# HISTORIC AND DESIGN REVIEW COMMISSION

**HDRC CASE NO:** 2018-423  
**ADDRESS:** 2042 W KINGS HWY  
**LEGAL DESCRIPTION:** NCB 1942 BLK 30 LOT 18  
**ZONING:** R-6 H  
**CITY COUNCIL DIST.:** 7  
**DISTRICT:** Monticello Park Historic District  
**APPLICANT:** Arnold & Pamela Flather  
**OWNER:** Arnold & Pamela Flather  
**TYPE OF WORK:** Fenestration modifications, driveway modifications  
**APPLICATION RECEIVED:** August 21, 2018  
**60-DAY REVIEW:** October 22, 2018  
**REQUEST:**

The applicant is requesting a Certificate of Appropriateness for approval to:

32" x 46" Window Conversion (8x8, 6x8 Iceberg)

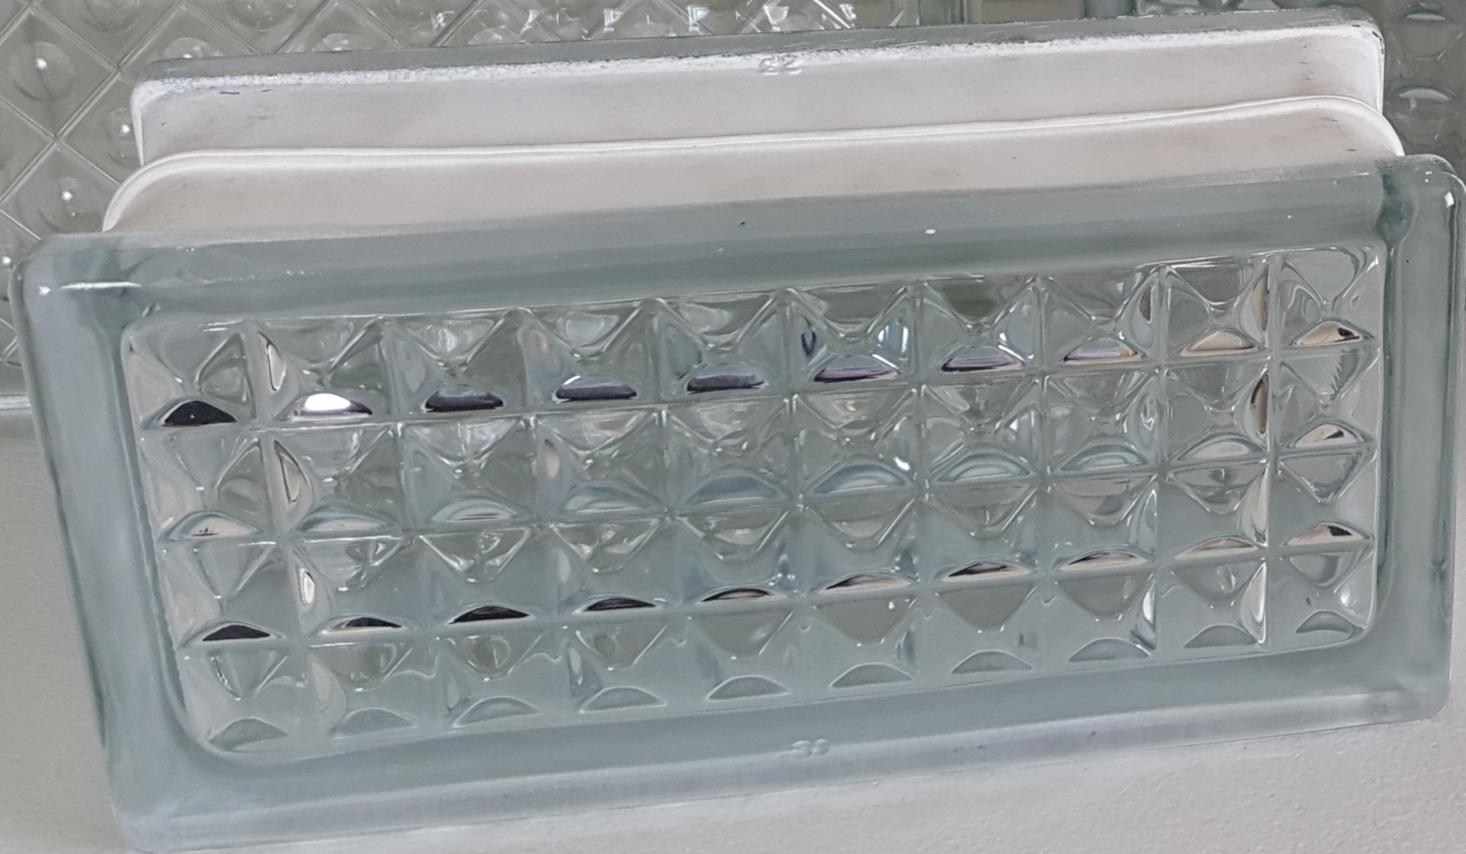
- b. WINDOW REPLACEMENT – The applicant has proposed to replace a non-original aluminum one over one window on the west façade of the structure with glass block. The window is partially visible from the public right-of-way. According to the Historic Design Guidelines, non-historic incompatible windows should be replaced with windows that are typical of the architectural style of the building. While staff finds that the window is eligible for replacement, staff finds that the installation of glass block is incompatible for the style of the home.

Item 1, Staff recommends approval of the non-original window replacement based on finding b with the following

- i. That the replacement windows be made of wood and a final window manufacturer specification be submitted to staff for review and approval and meet the following stipulations: that meeting rails be no taller than 1.25” and stiles no wider than 2.25”. There should be a minimum of two inches in depth between the front face of the window trim and the front face of the top window sash. This must be accomplished by recessing the window sufficiently within the opening. Window trim must feature traditional dimensions and architecturally appropriate sill detail. Window track components must be painted to match the window trim or concealed by a wood window screen set within the opening.
